WSU University Services Building Roof and Structure Repairs 2018

WSU PROJECT #: 060-313960

ISSU	ED FOR	Bid
ISSUED	FOR DATE	07/03/18
REV. NO.	REV. NO. DATE	DESCRIPTION
1	07-19-18	ADDENDUM #2
	<del> </del>

CONSTRUCTION PHASING

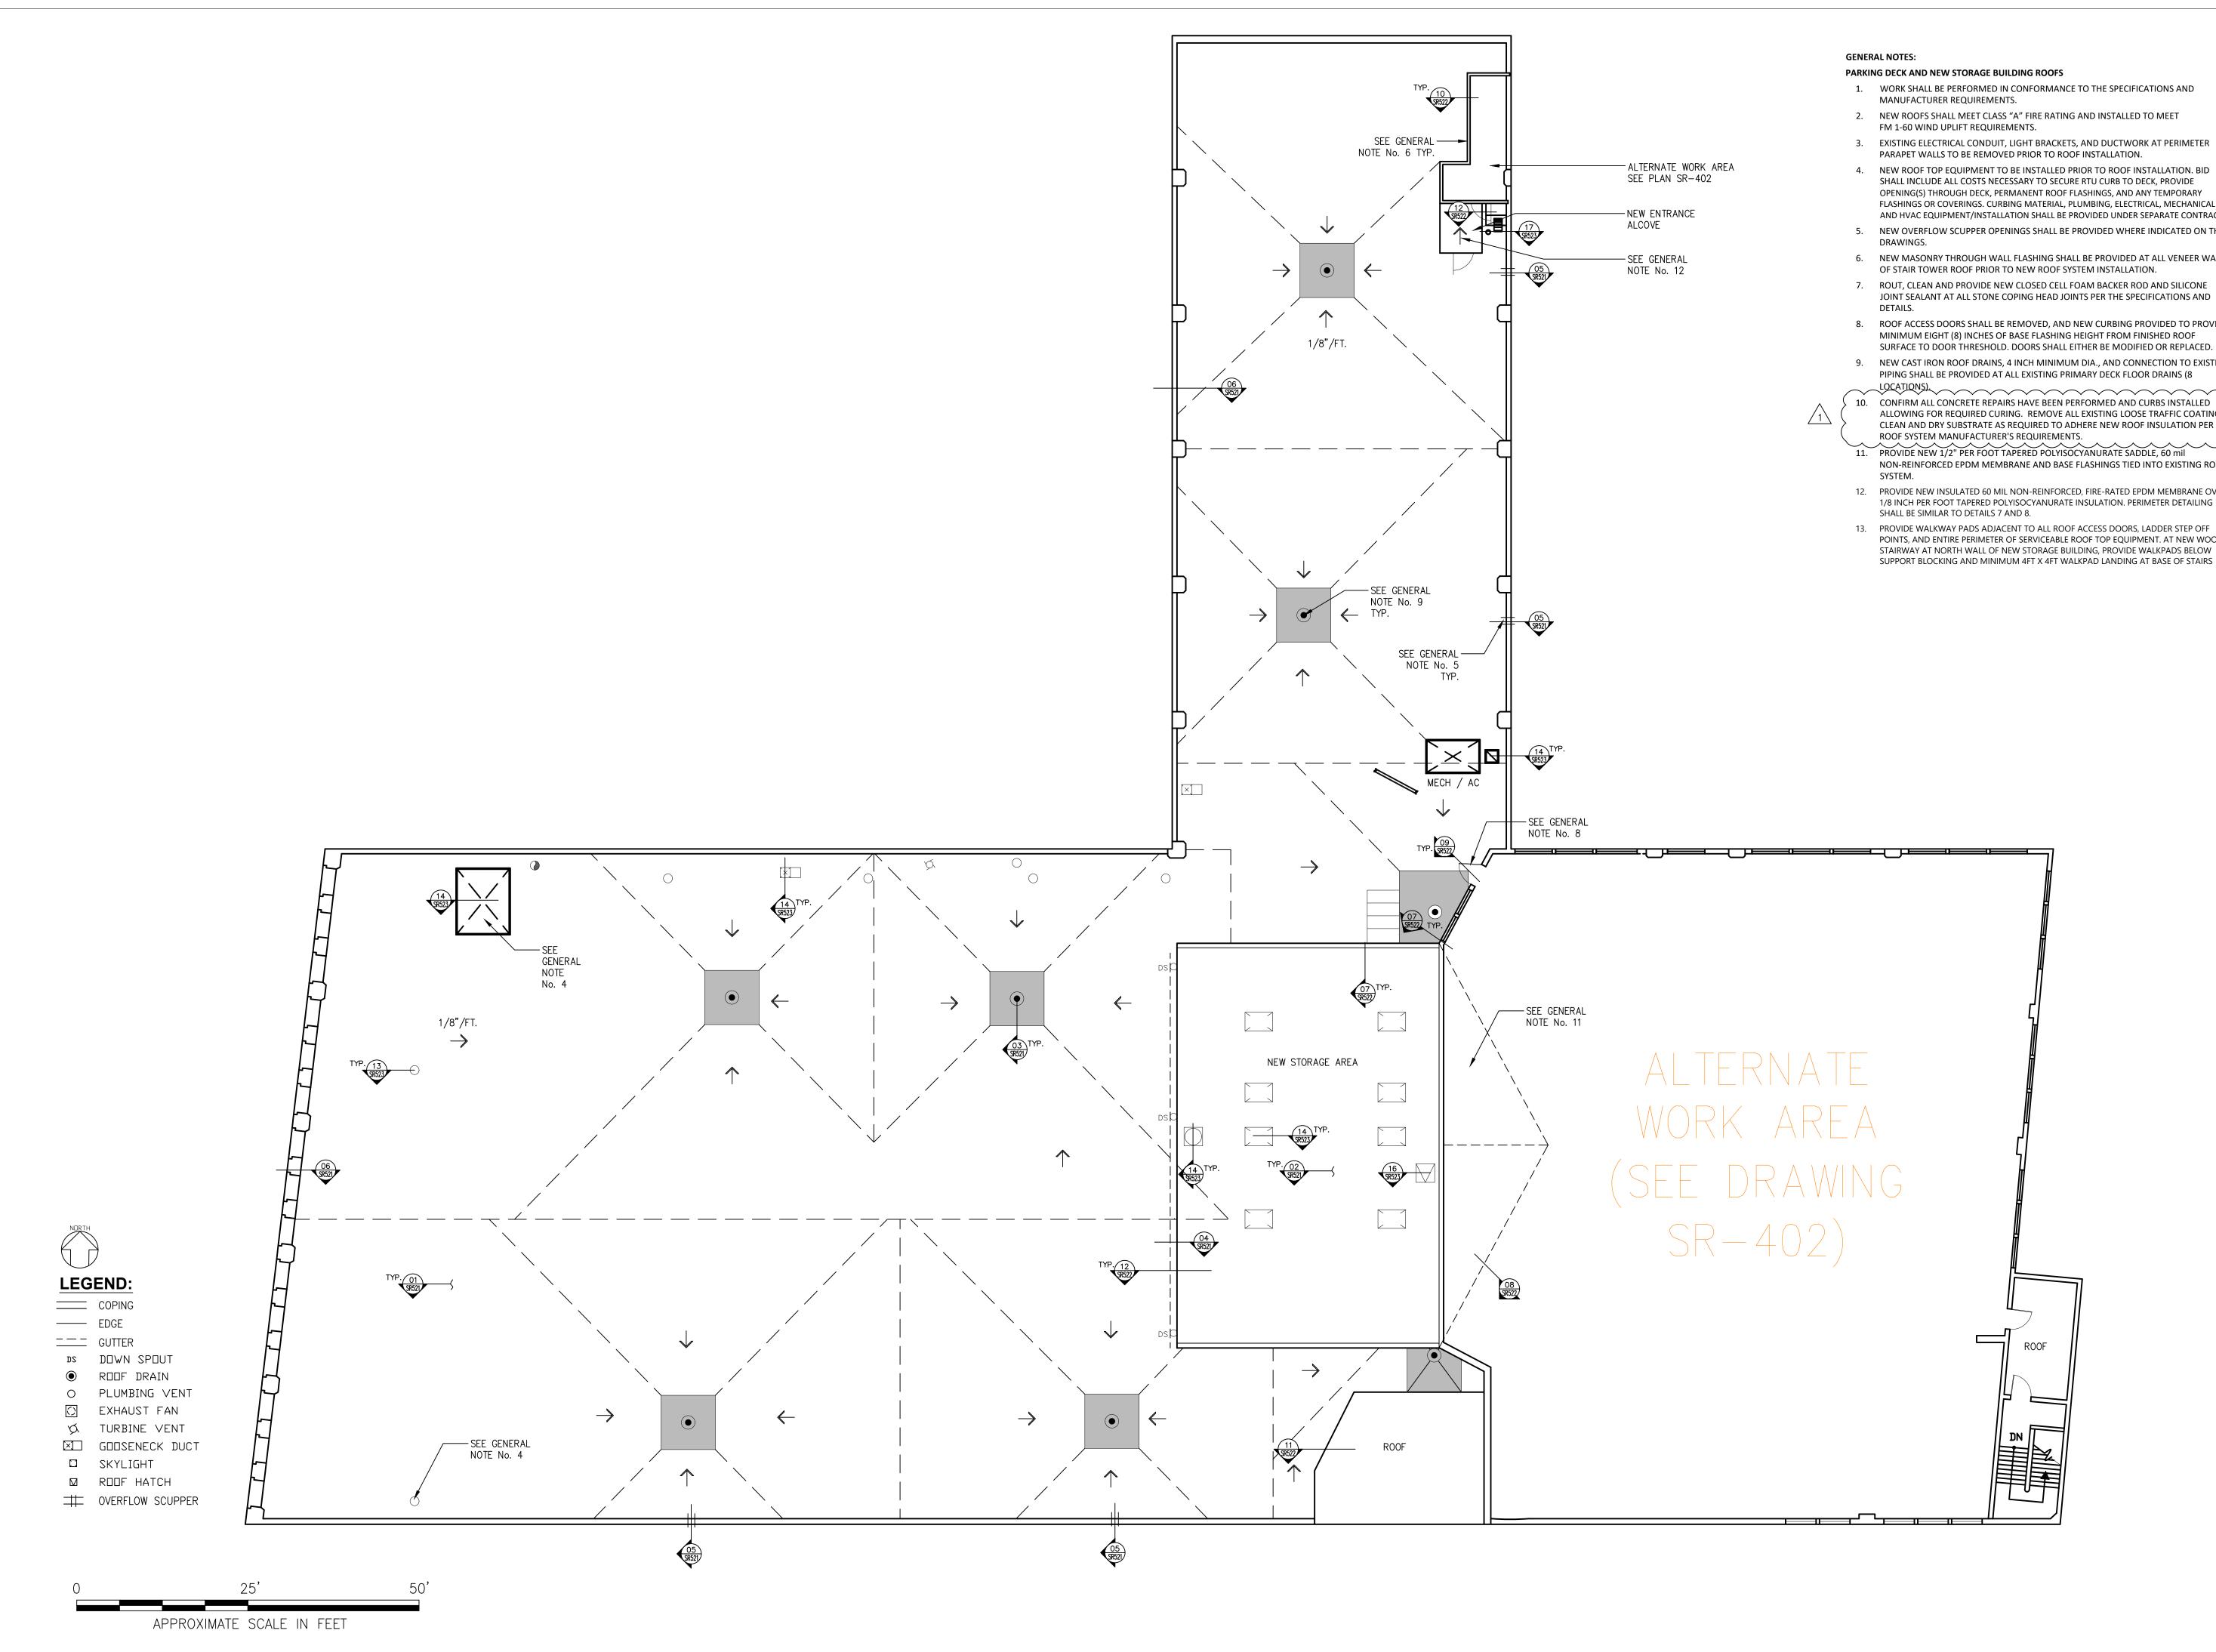
10. ALL NEW ENCLOSURES AND ROOFING SHALL BE WATERTIGHT BY OCTOBER 31, 2018.

SHEET TITLE Roof Replacement Plan

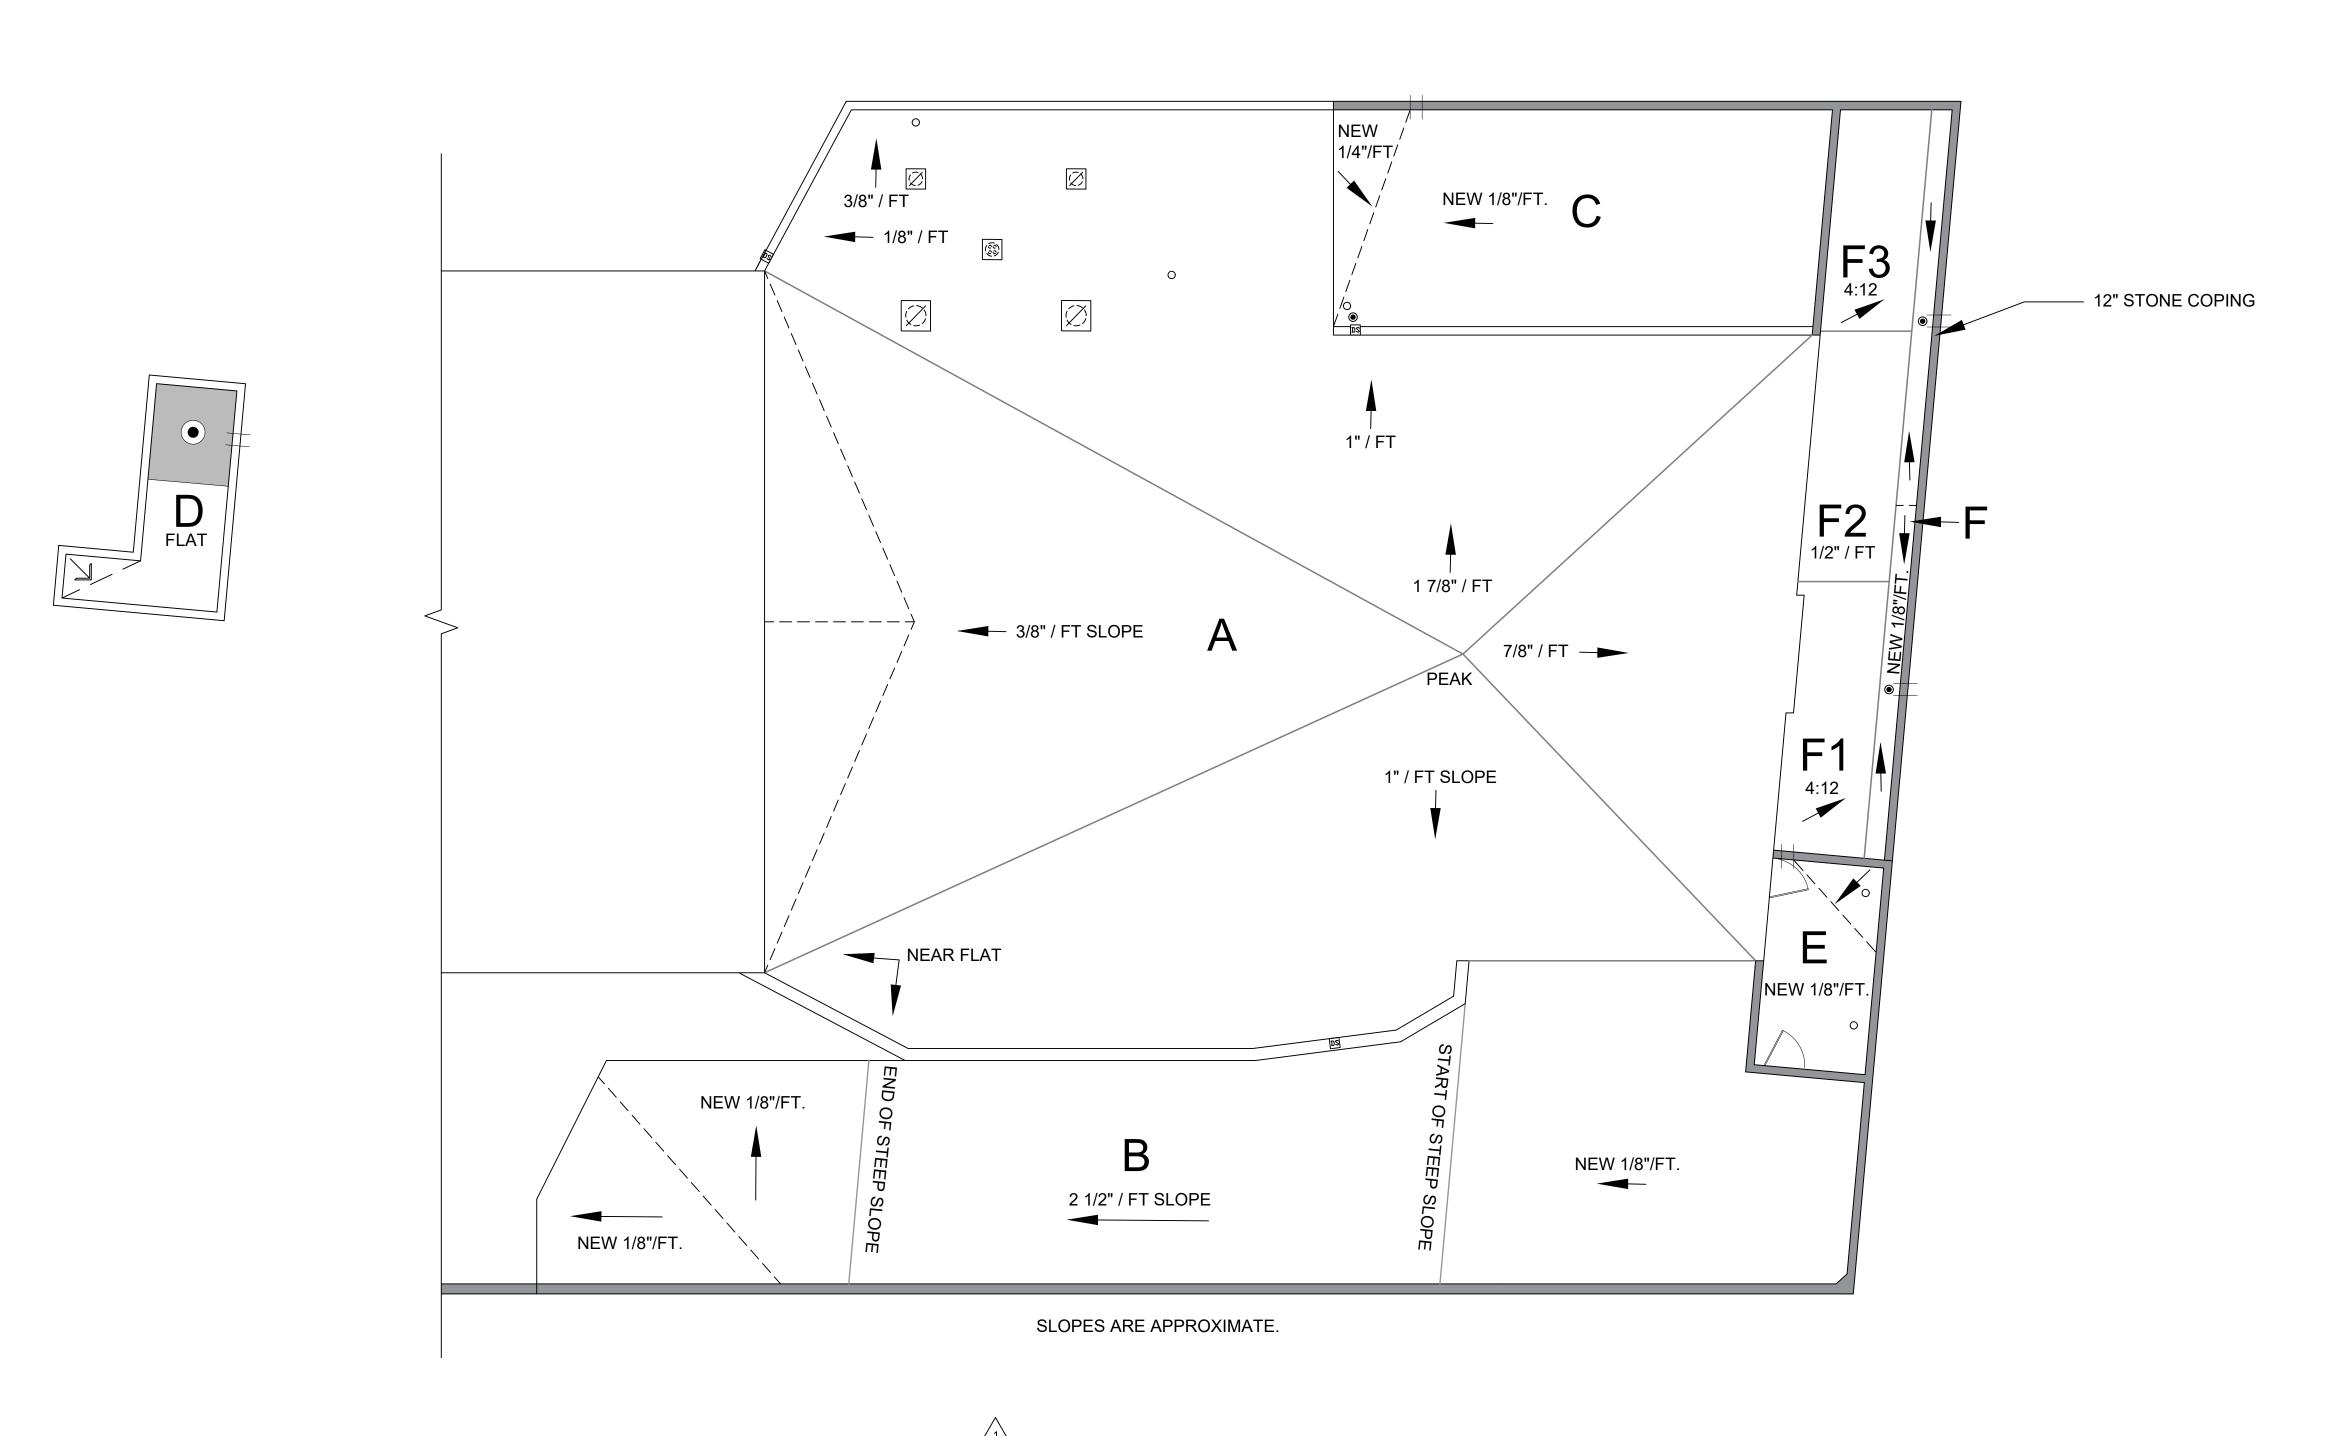
- NON-REINFORCED EPDM MEMBRANE AND BASE FLASHINGS TIED INTO EXISTING ROOF
- 12. PROVIDE NEW INSULATED 60 MIL NON-REINFORCED, FIRE-RATED EPDM MEMBRANE OVER 1/8 INCH PER FOOT TAPERED POLYISOCYANURATE INSULATION. PERIMETER DETAILING
